## Technical Guidance Committee Meeting

### Minutes

Wednesday, May 18, 2016

**Conference Room B  
Department of Environmental Quality  
1410 North Hilton  
Boise, Idaho**

Figure 4-9. Cross-sectional view of typical filter, valve, and meter assembly for a noncontinuous flush system.

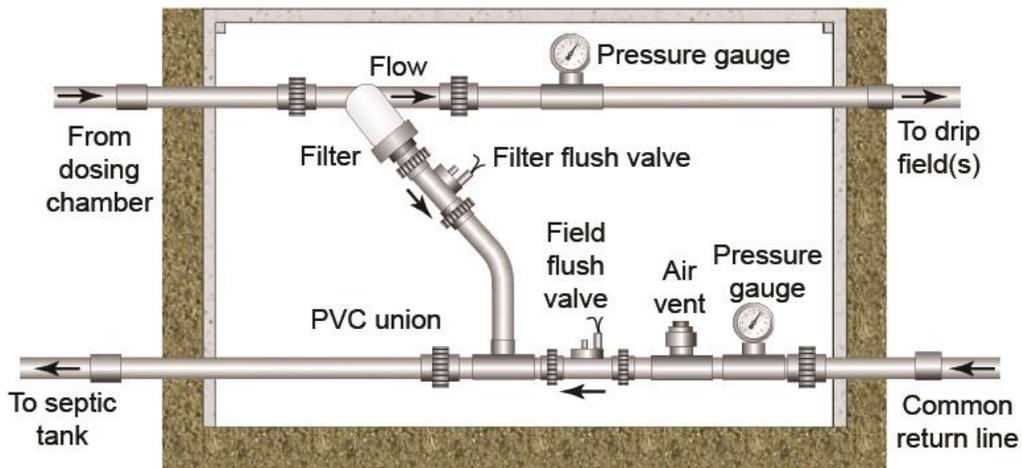
The committee requested the Tyler Fortunati have a pressure gauge added to the portion of Figure 4-9 labeled "to drip field".
